| Dist | COUNTY | ROUTE | POST MILES TOTAL PROJECT | SHEET No. | TOTAL SHEETS |
|---|---|---|---|---|---|
| 04 | Ala | 580 | R14.6/R21.6 | 101 | 804 |

C-25

3 REVISED PER ADDENDUM No. 3 DATED AUGUST 22, 2012

**CONSTRUCTION DETAILS**
**TEMPORARY CREEK DIVERSION**
SCALE: AS SHOWN

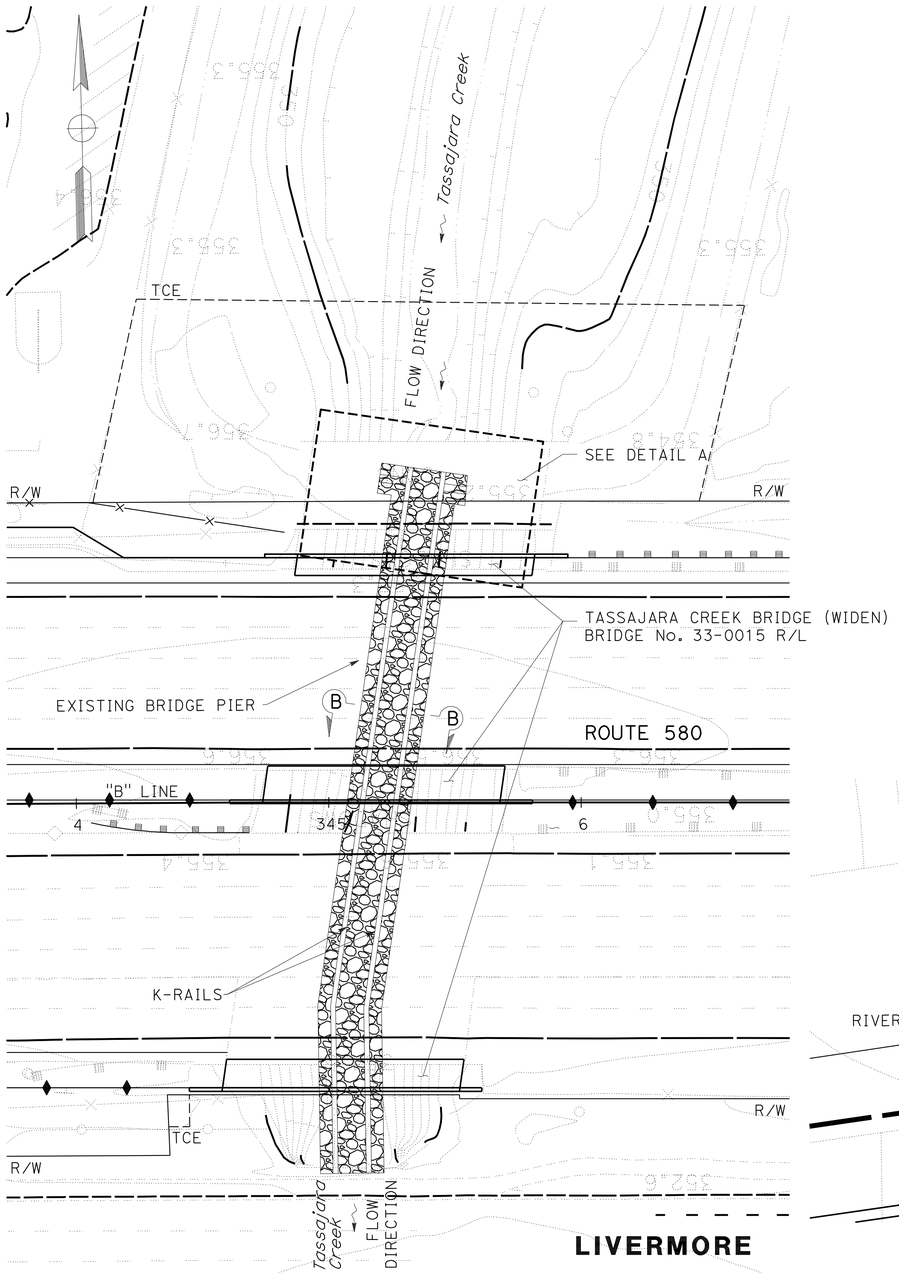
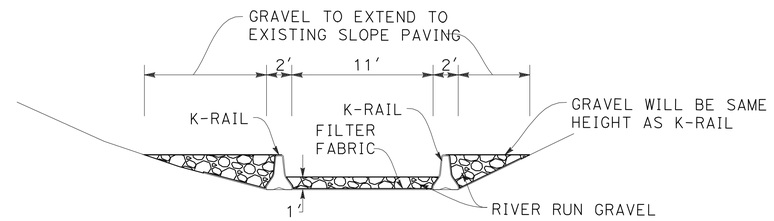
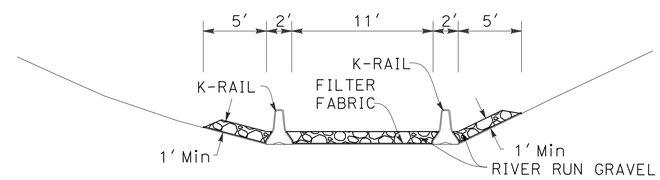
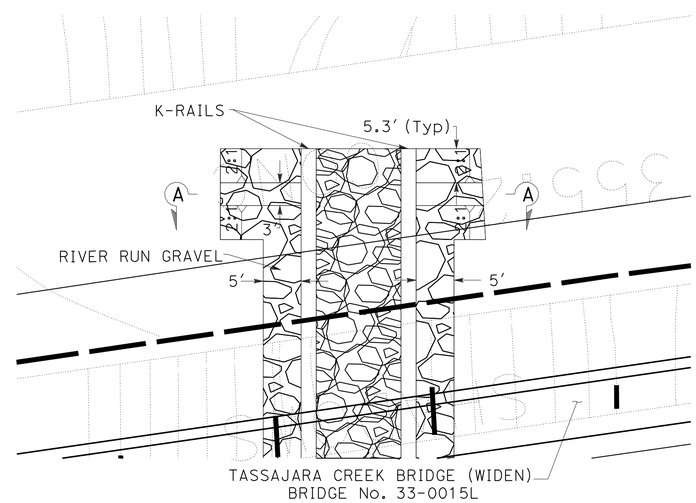
3 ~~2. FROM OCTOBER 15 TO APRIL 15, CONTRACTOR SHALL NOT PERFORM ANY WORK IN THE CREEK, FROM THE TOP OF BANK TO THE TOP OF BANK.~~

2 ~~3.~~ FOLLOWING PROJECT COMPLETION, TEMPORARY CREEK DIVERSION REMOVED. GRADES SHALL BE RESTORED PER NOTE 1.

3 3 ~~4.~~ SEE DQ-1 FOR APC ALLOWABLE PIPE MATERIAL.

3 **REVISED PER ADDENDUM No. 3 DATED AUGUST 22, 2012**

**STAGE CONSTRUCTION STAGE 1**

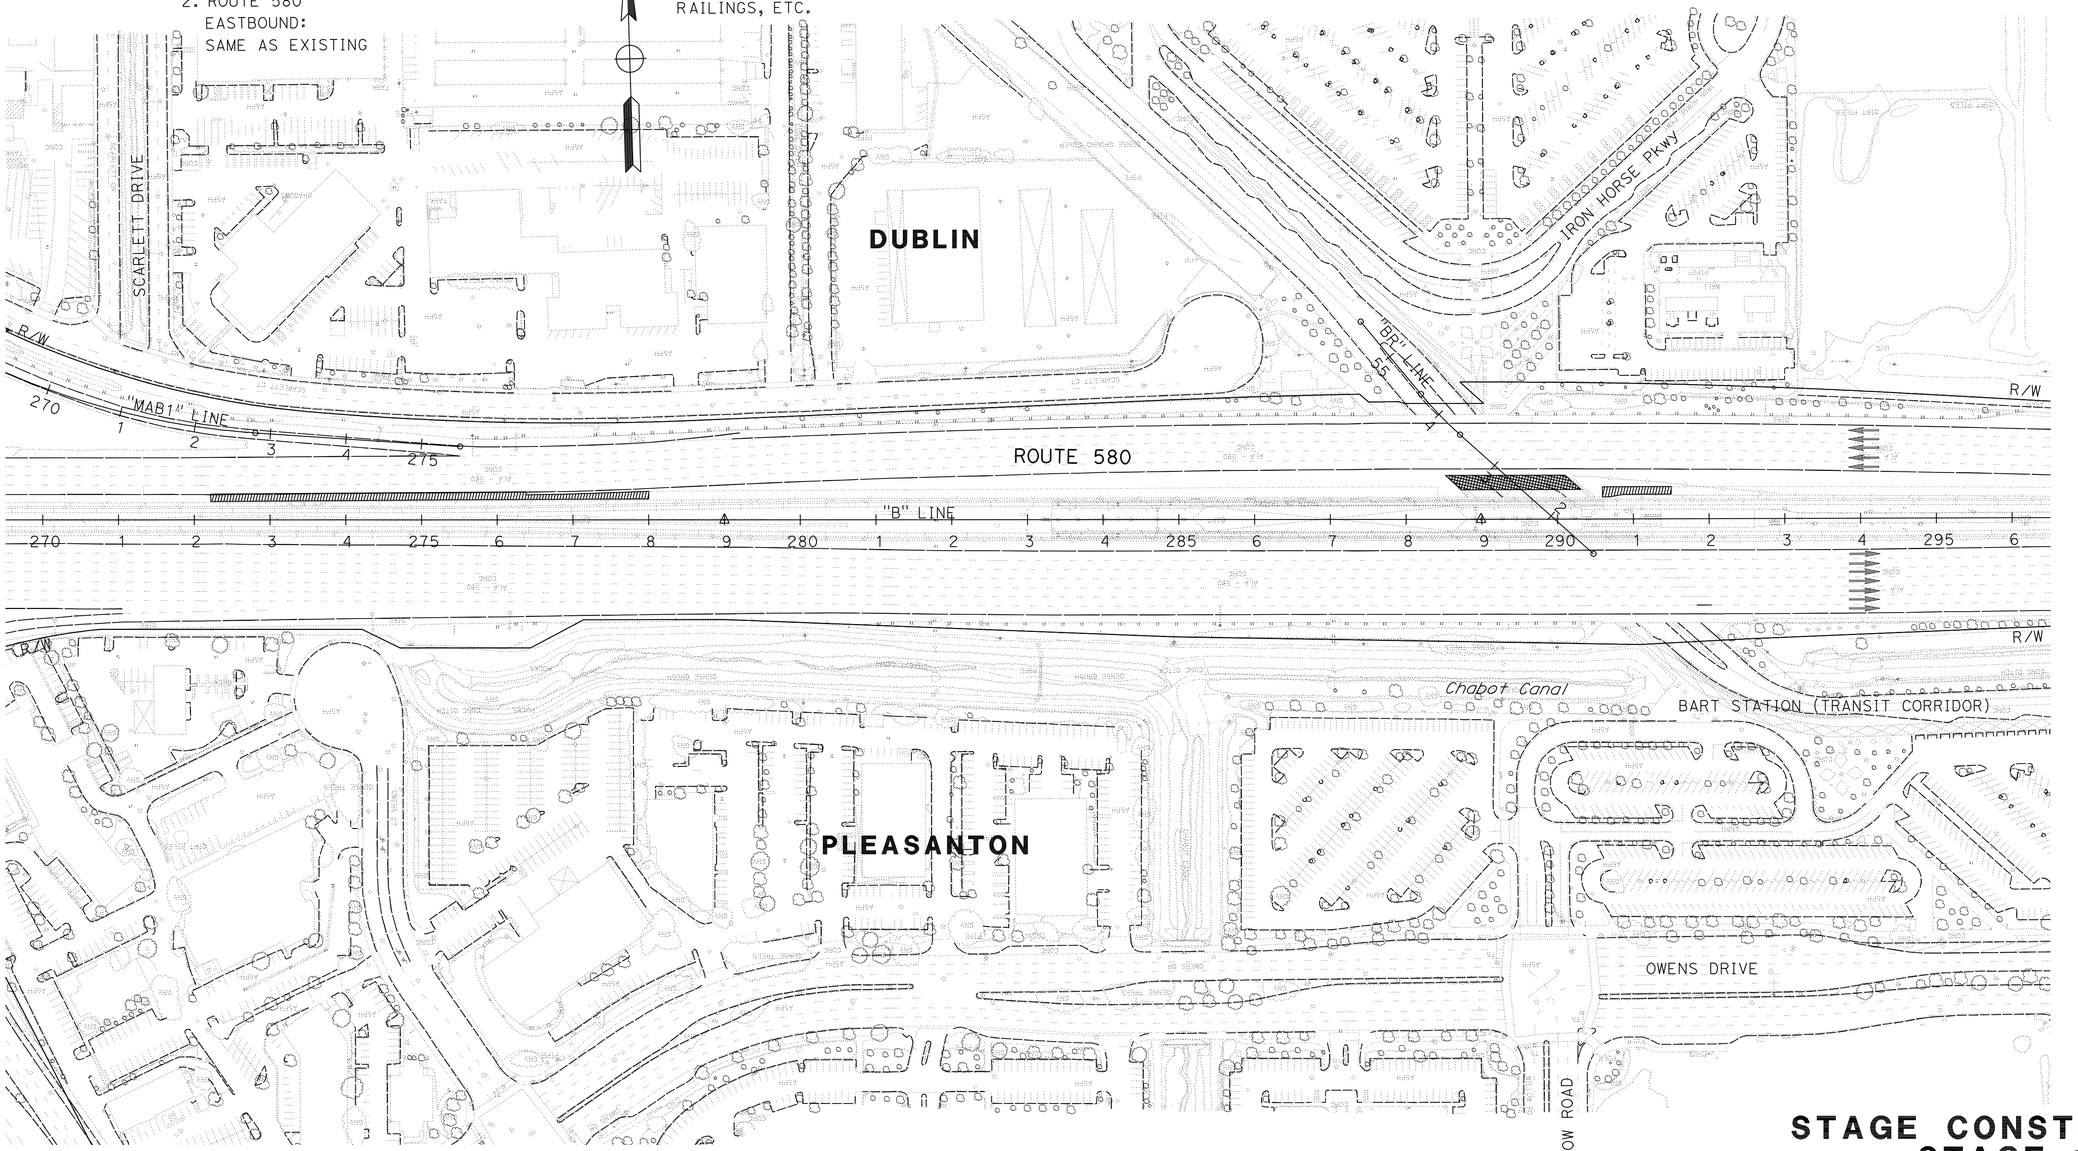
| LINE | STATION LIMITS | CONSTRUCTION |
|---|---|---|
| 3 B | 344+70 TO 345+68 | 5. CONSTRUCT WIDENING OF WB INSIDE TASSAJARA CREEK BRIDGE STRUCTURE. |
| 3 B | 195+10 TO 300+80 | ~~5.~~ CONSTRUCT SLAB REPLACEMENT AREAS.<br>6. SEE LAYOUT SHEETS FOR EXACT LOCATIONS. |

3 **REVISED PER ADDENDUM No. 3 DATED AUGUST 22, 2012**
